NRL/MR/7441--94-7516

Digital Mapping, Charting, and Geodesy Analysis Program Technical Review of Vector Smart Map Prototypes 1 and 2

January 19, 1995

Figure 2b. Data content errors in railroad

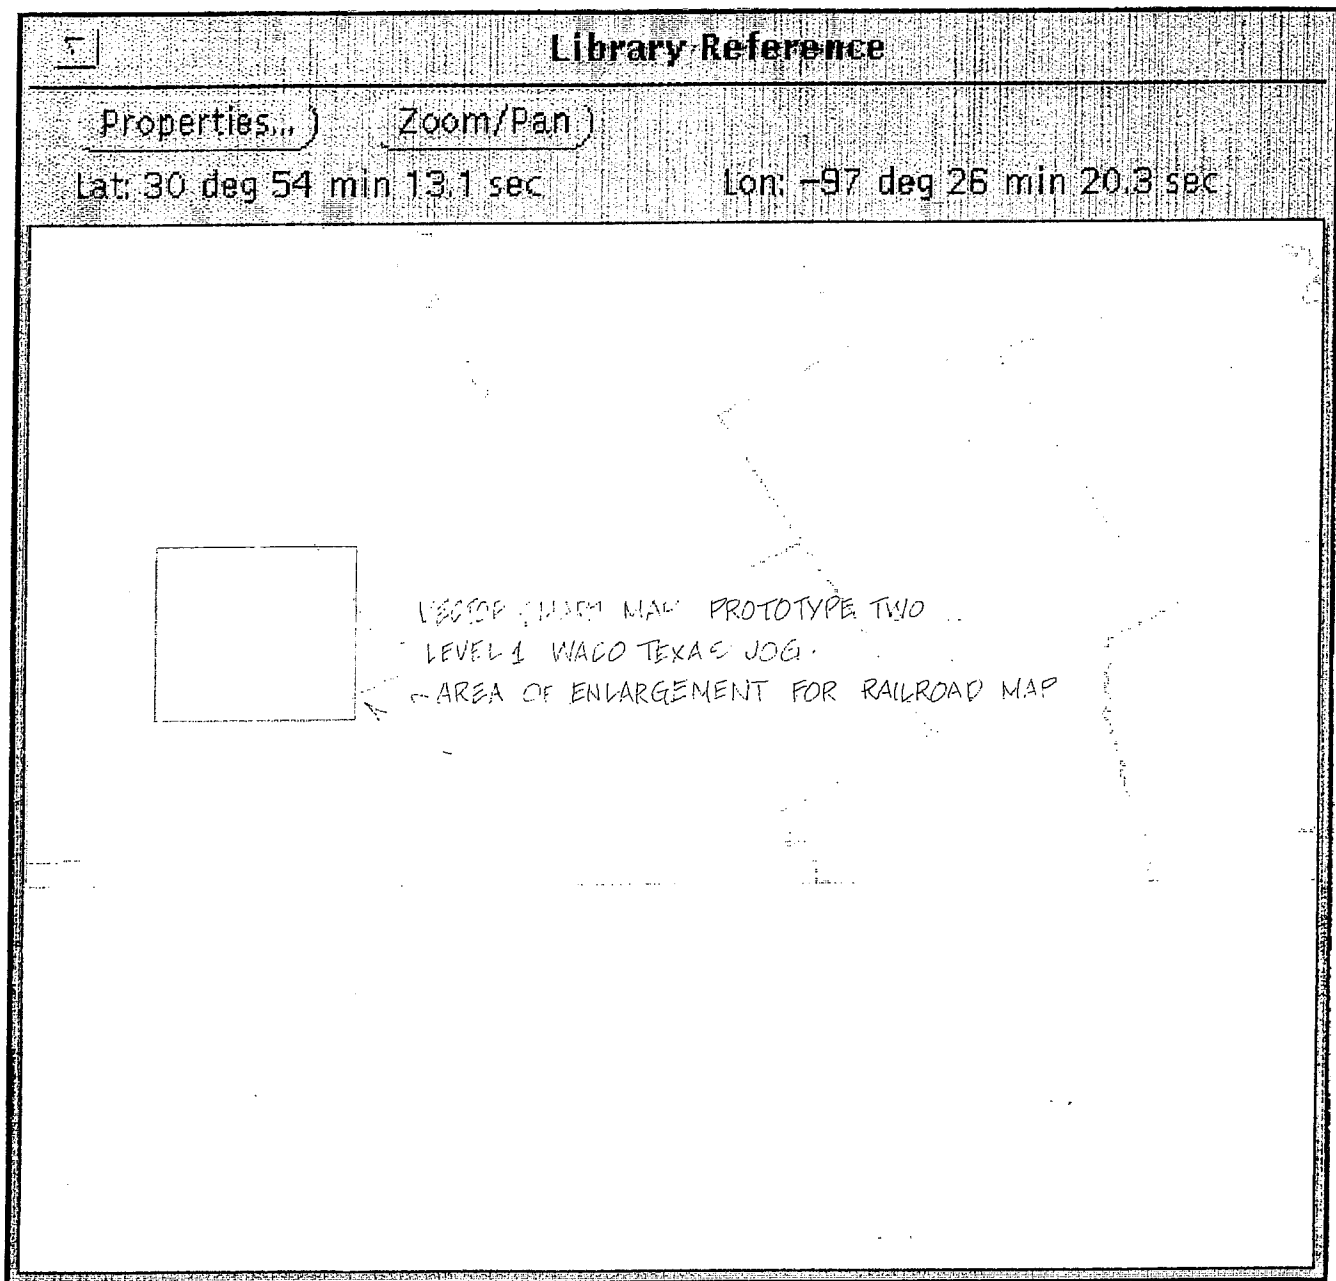
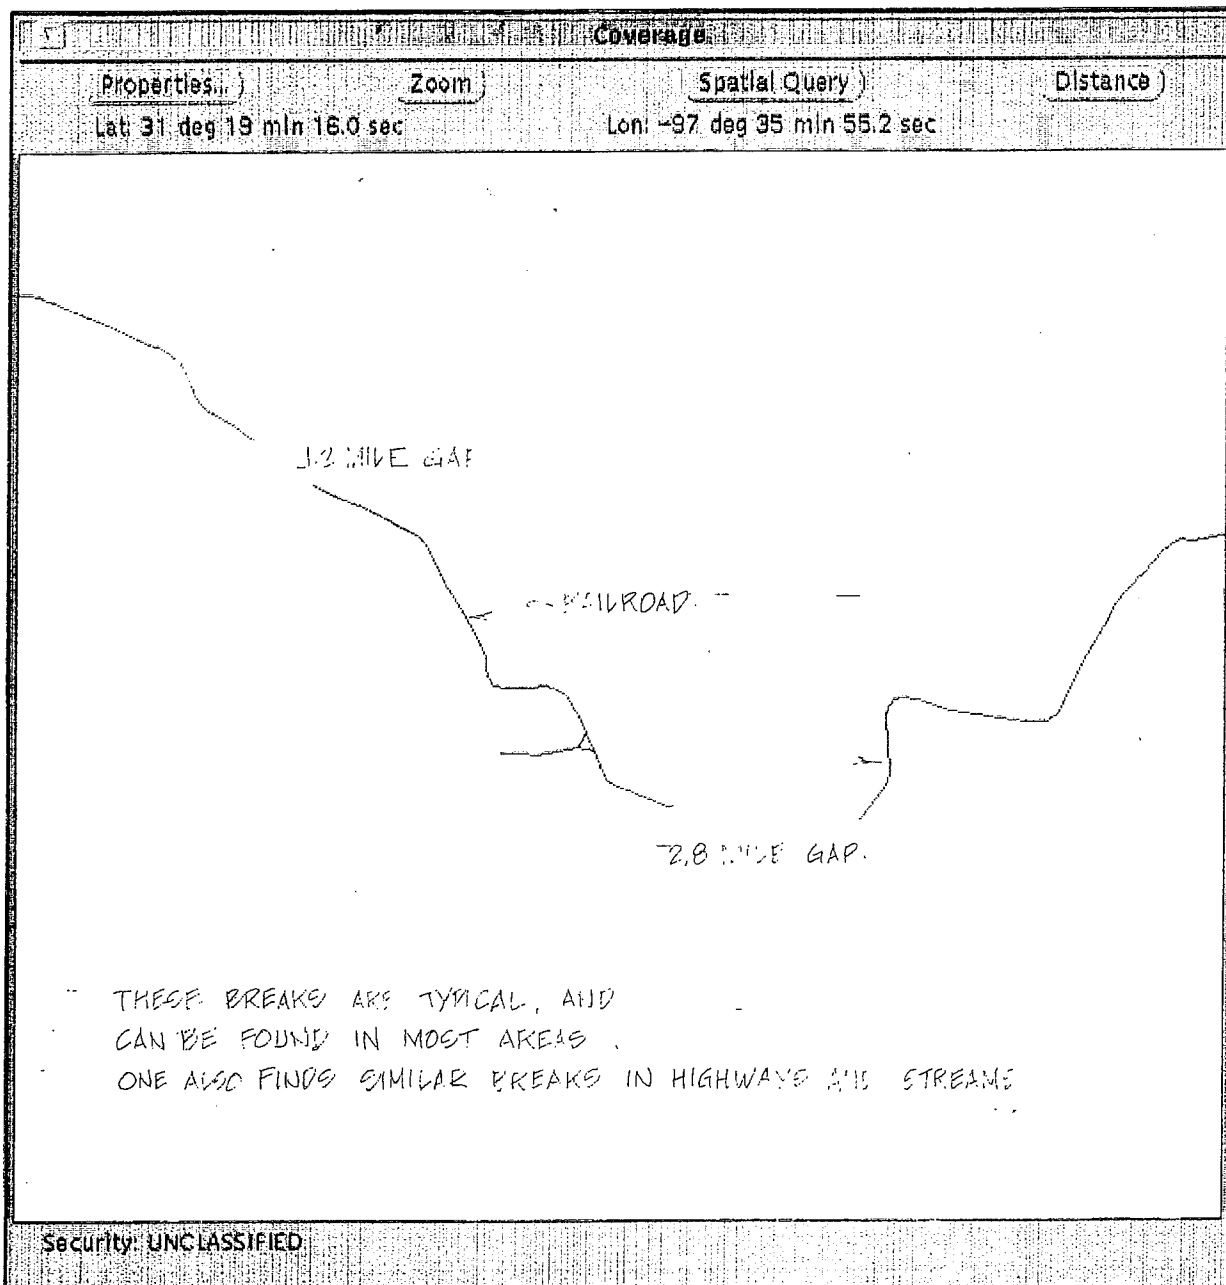
Figures 2a and 2b display an area near Waco and an associated railroad in the Transportation coverage. Unusually large "gaps" are present in the data and could be a result of faulty digitization. Data omission errors and improper registration are displayed in Figures 3 through 5. The circled items in Figure 3 show incomplete "pieces" of roads and data omissions of the railroad in places where a railroad and road are in close proximity. In Figure 4, water courses have clear data omissions. Figure 5 shows apparent shifts in geographical position between the Hydrography and Transportation coverages.

Figure 6a. "Missing" river/political boundary in hydrography coverage

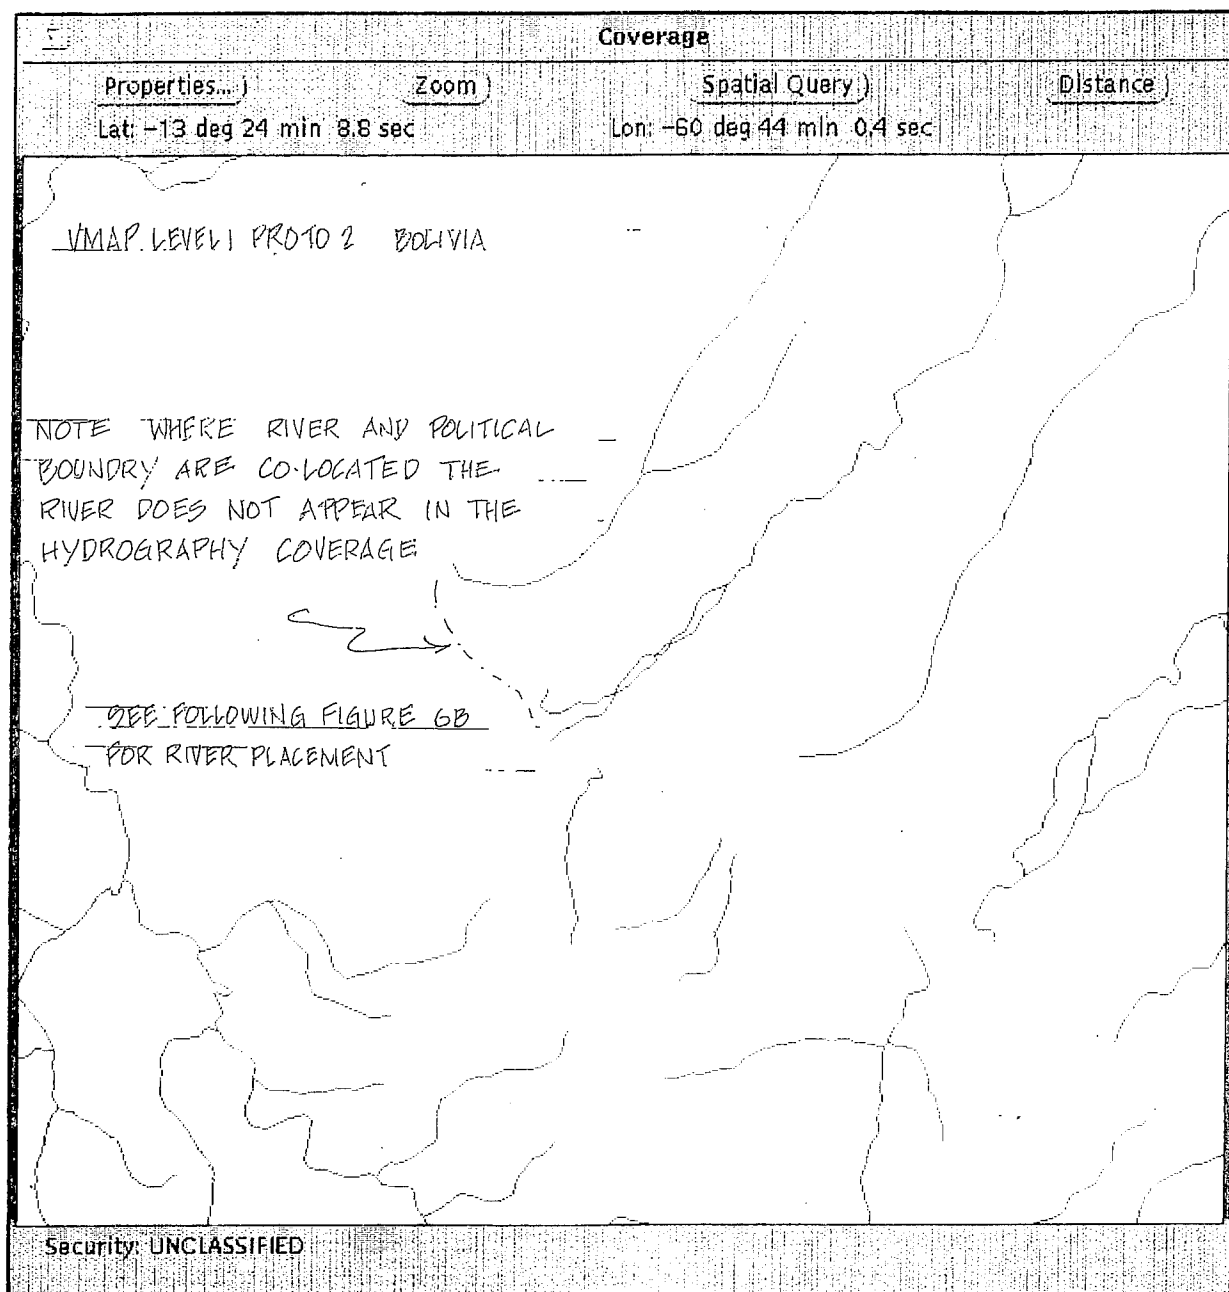
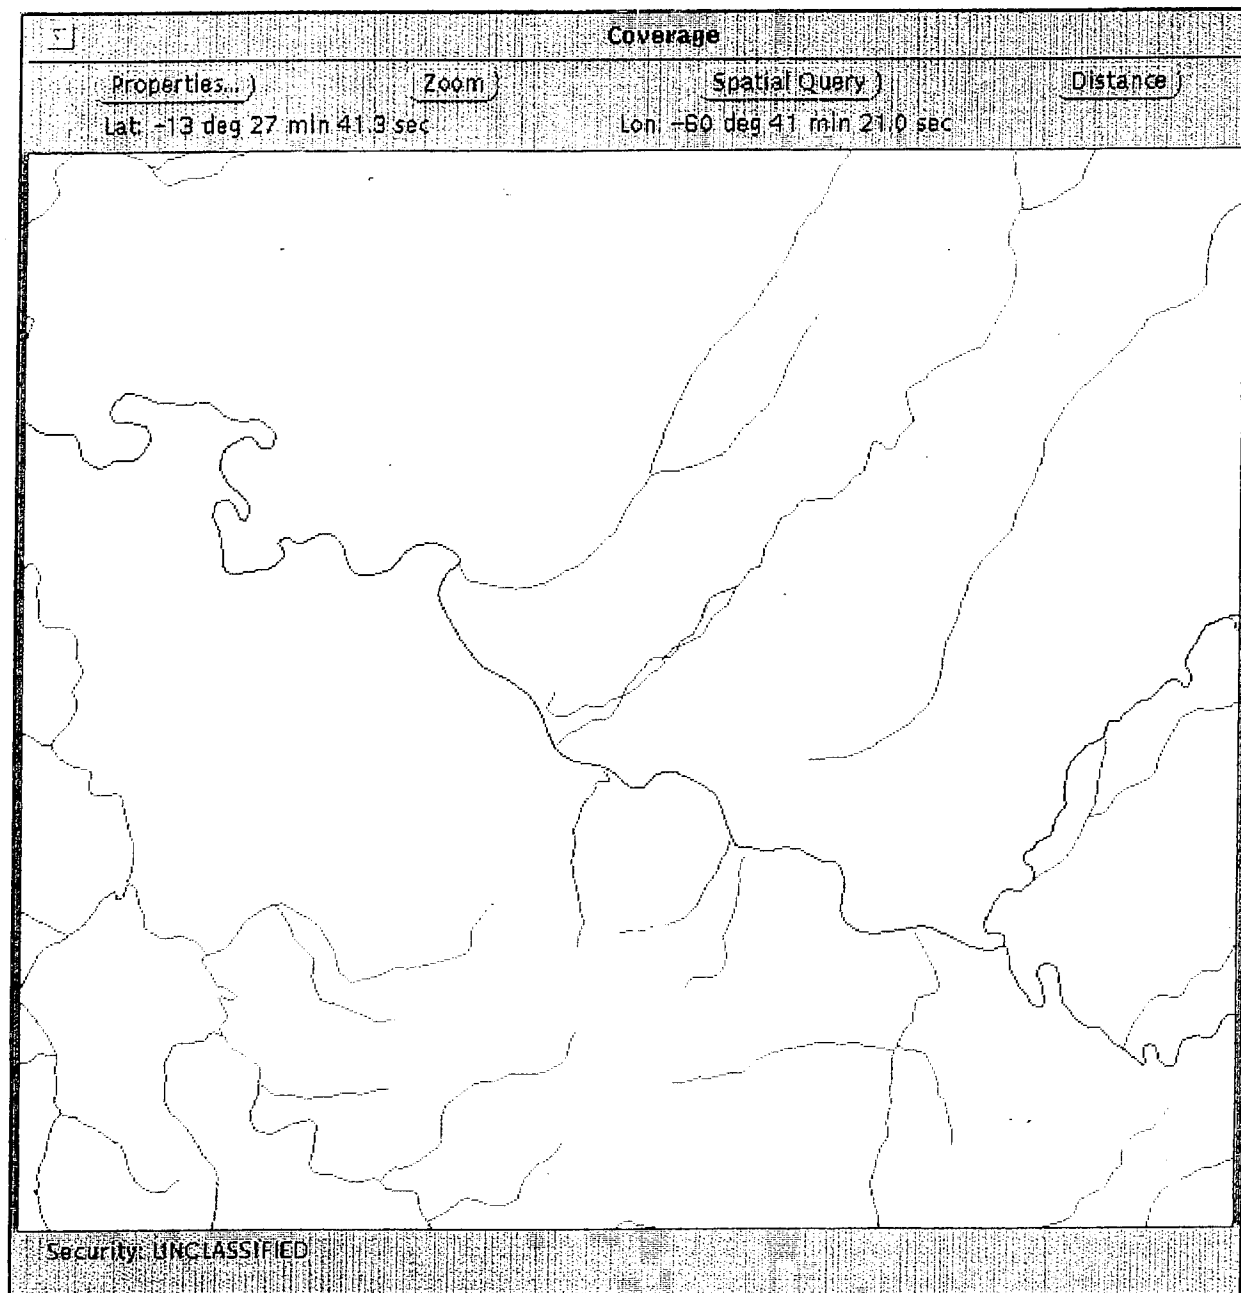
Figures 6a and 6b display water courses from the Hydrography coverage of the medium resolution Bolivia database. The Boundaries coverage political boundary line, between Bolivia and Brazil is determined by a river. This river is not recorded in the Hydrography coverage where one would expect, which caused some confusion. However, upon further study, the river was located in the *area* feature class Water Courses and Bodies in the Hydrography coverage.

Figure 7b. Data content errors in roads/railroads

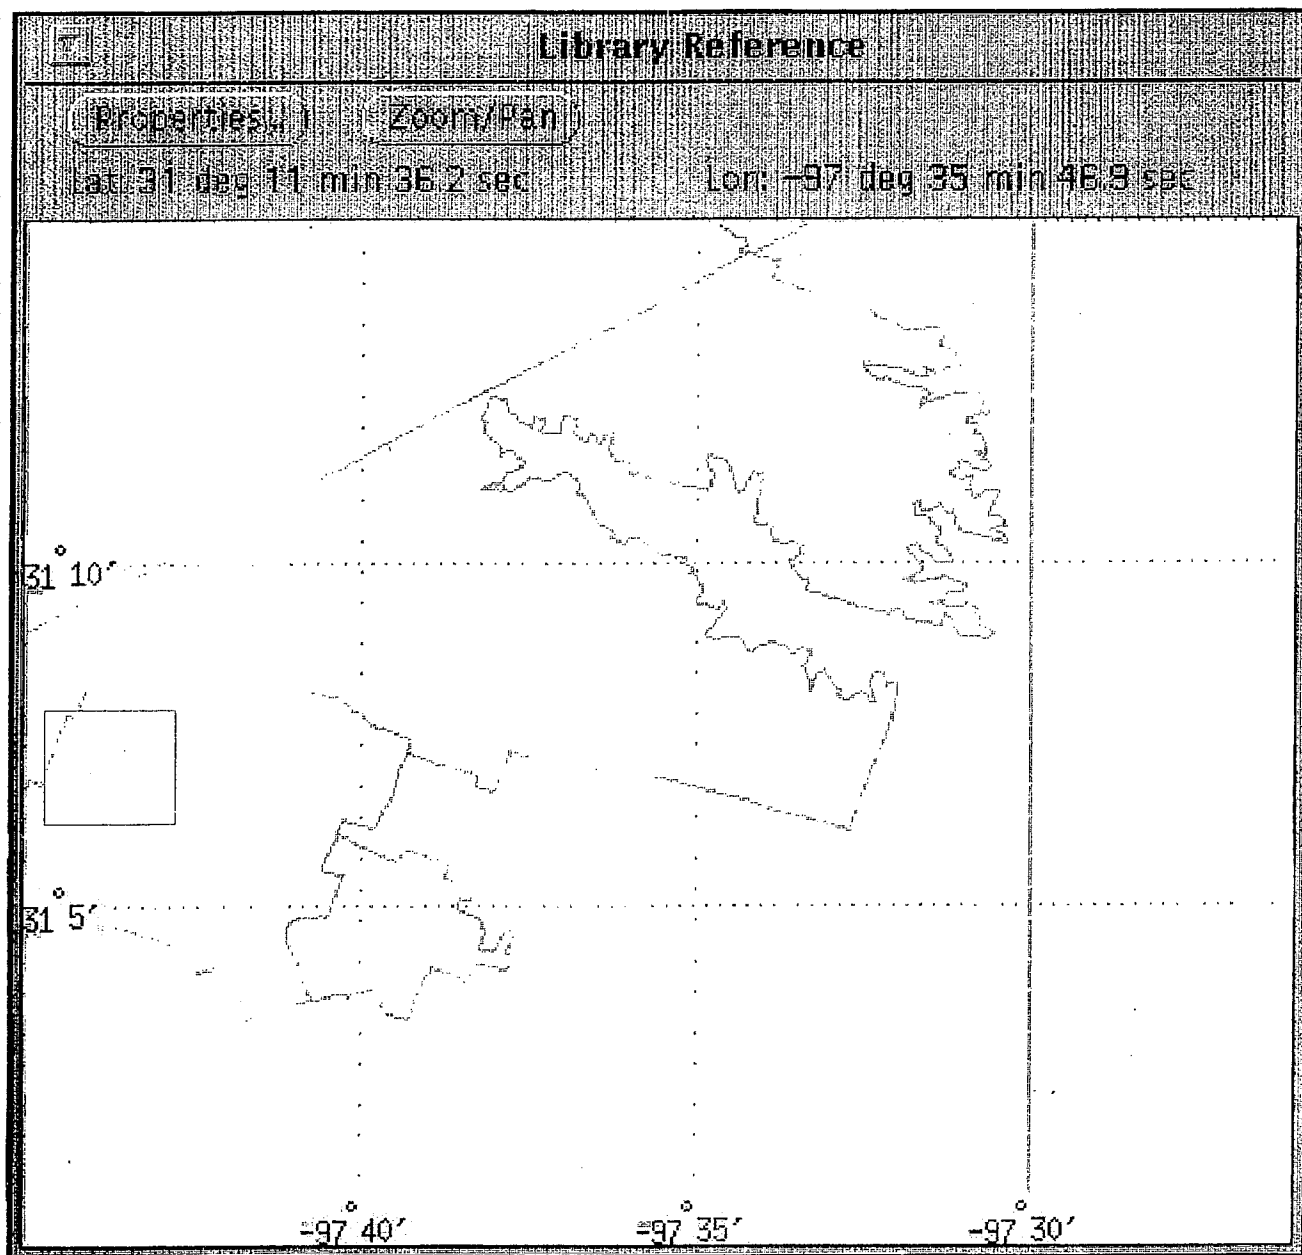
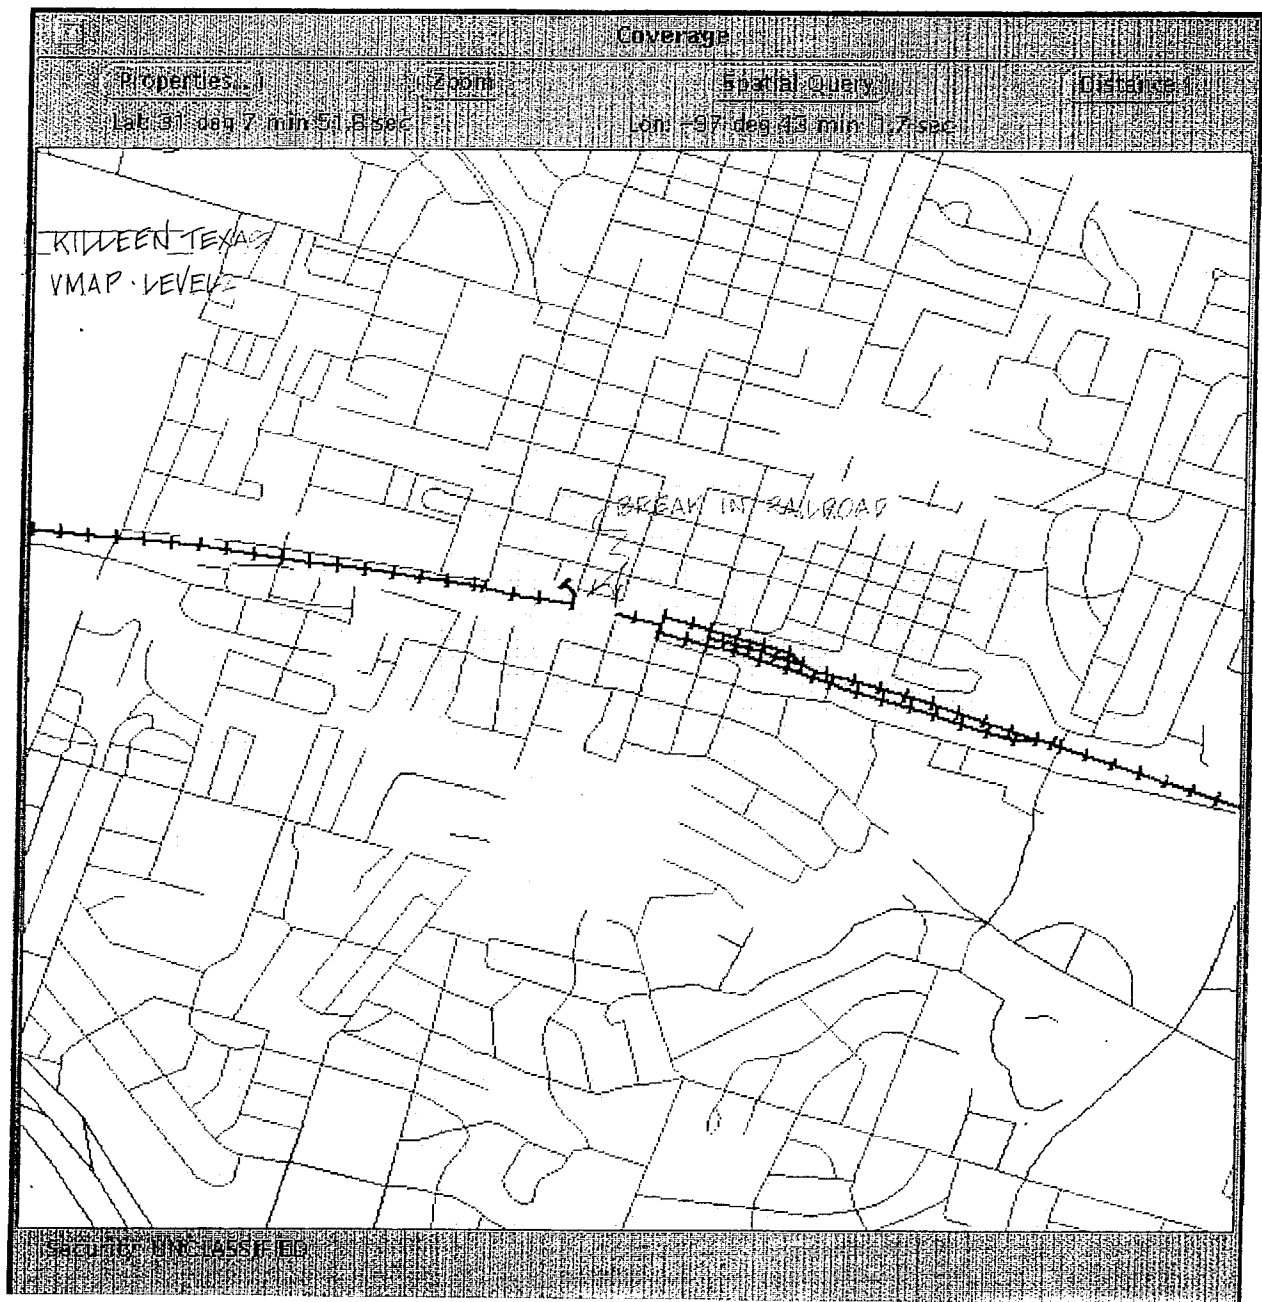
Similar to the medium resolution case, the high resolution data of Texas had several digitization and registration problems. Figures 7a and 7b present one such example (Figure 7a gives the reference area). A railroad from the Transportation coverage is displayed, together with the feature class Roads in the city Killeen. This railroad (Name: Atchison Topeka and Santa Fe) is operational but has a "hole" in the data, as indicated in the figure. Additionally, some roads appear to be disconnected, which seems to indicate incomplete data.
